L-2001-036  
10 CFR 50.80  
10 CFR 50.90

Re: St. Lucie Units 1 and 2  
Docket Nos. 50-335, 50-389  
Turkey Point Units 3 and 4  
Docket Nos. 50-250, 50-251  
Application for Order and Conforming License Amendments  
Transfer of Operating Authority

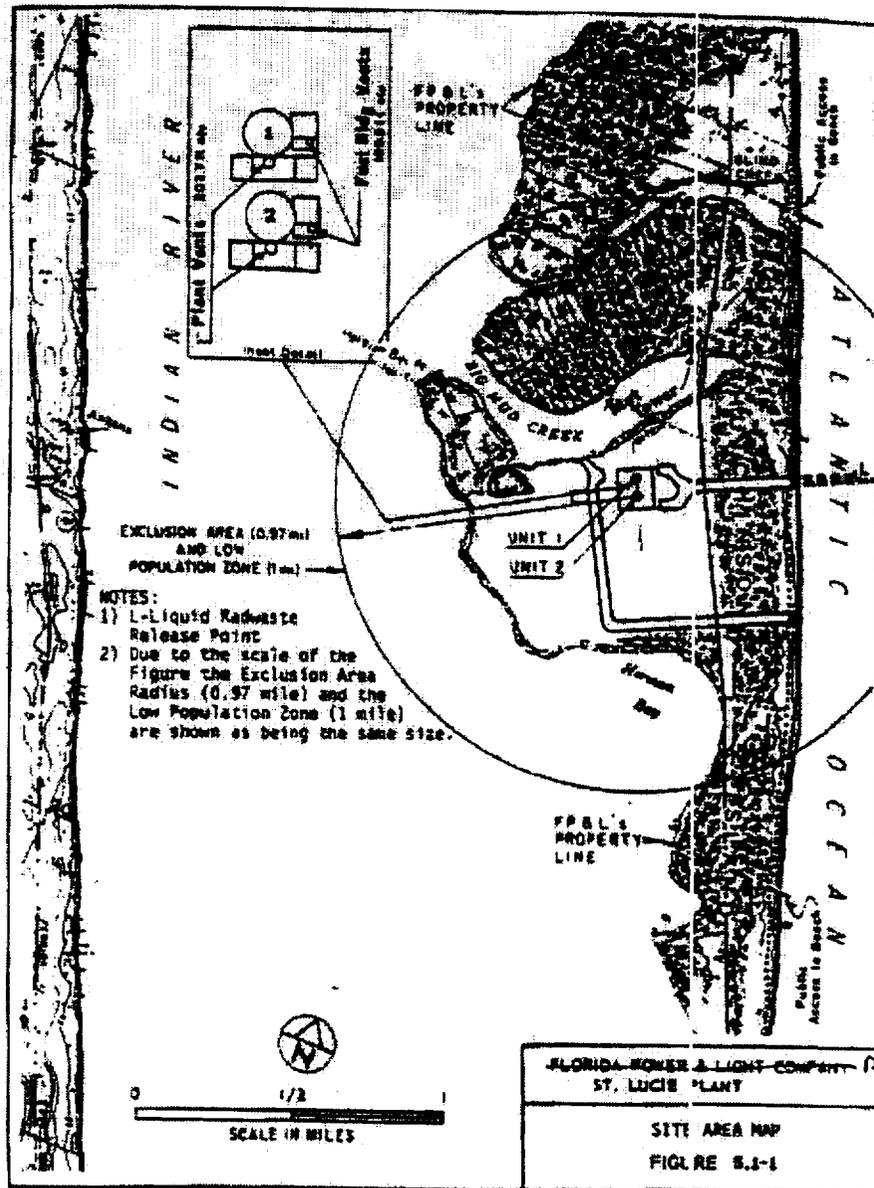
4.7.9.1.1 **Test Requirements** – Each sealed source shall be tested for leakage and/or contamination by:

- a. The licensee, or *EWCB*
- b. Other persons specifically authorized by the Commission or an Agreement State.

4. Revise TS 4.7.9.1.1.a. to change [The licensee] to [WCB]
  5. Revise TS Figure 5.1-1 to delete reference to [Florida Power & Light Company] in the Figure title box

**6.6 REPORTABLE EVENT ACTION**

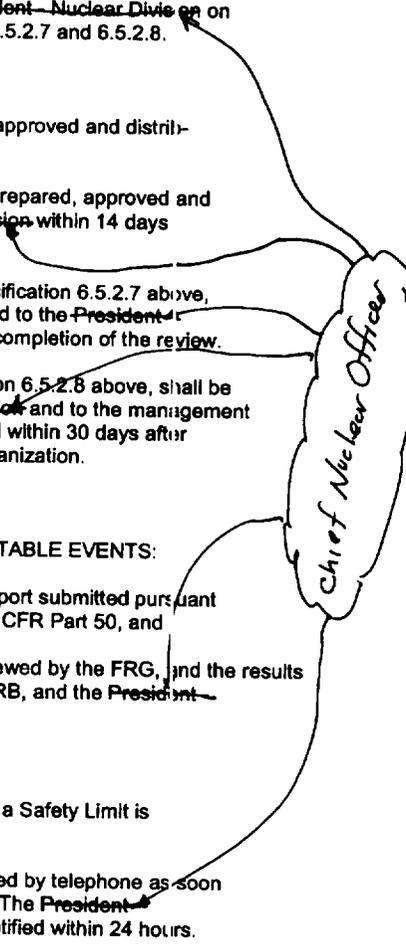
- a. The Commission shall be notified and a report submitted pursuant to the requirements of Section 50.73 to 10 CFR Part 50, and
- b. Each REPORTABLE EVENT shall be reviewed by the FRG, and the results of the review shall be submitted to the CNRB, and the ~~President—Nuclear Division~~.

16. Revise TS 6.5.2.10.c. to change [President-Nuclear Division] to [Chief Nuclear Officer]
  17. Revise TS 6.6.1.b. to change [President-Nuclear Division] to [Chief Nuclear Officer]

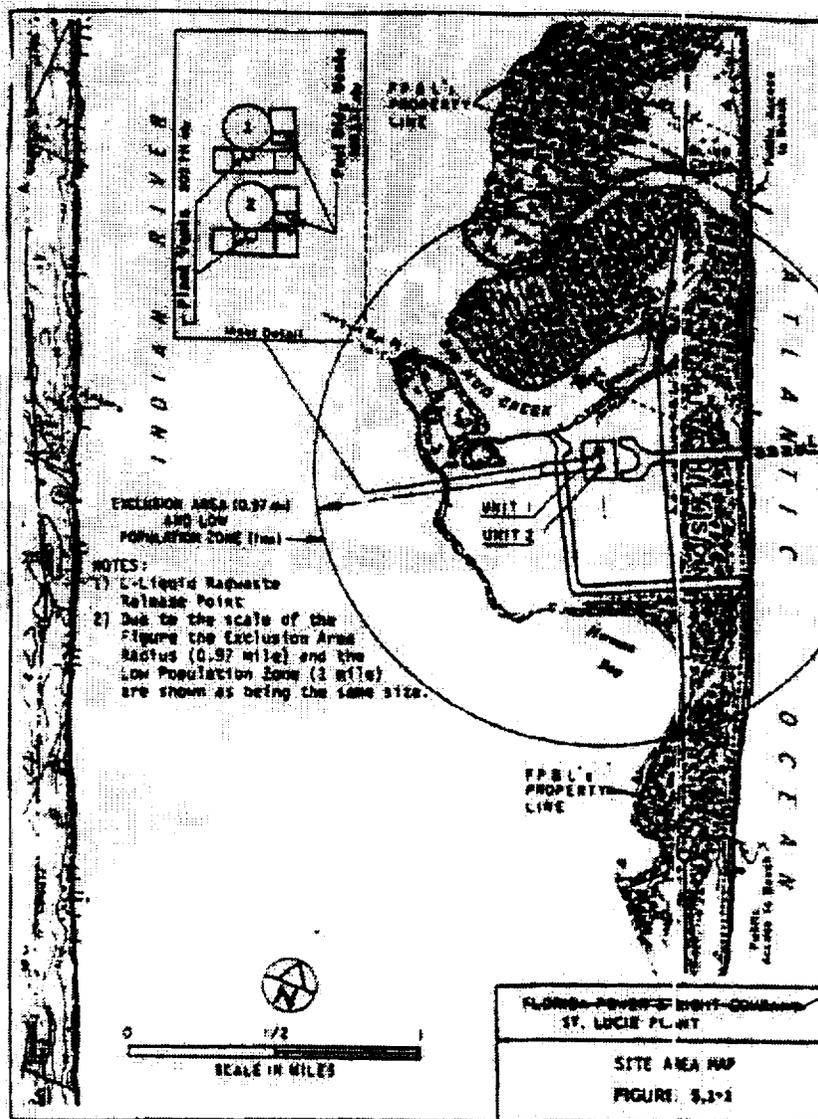
4.7.10.1 Test Requirements – Each sealed source shall be tested for leakage and/or contamination by:

- a. ~~The licensee~~ or <sup>WCB</sup>
- b. Other persons specifically authorized by the Commission or an Agreement State.

4. Revise TS 4.7.10.1.a. to change [The licensee] to [WCB]
  5. Revise TS Figure 5.1-1 to delete reference to [Florida Power & Light Company] in the Figure title box
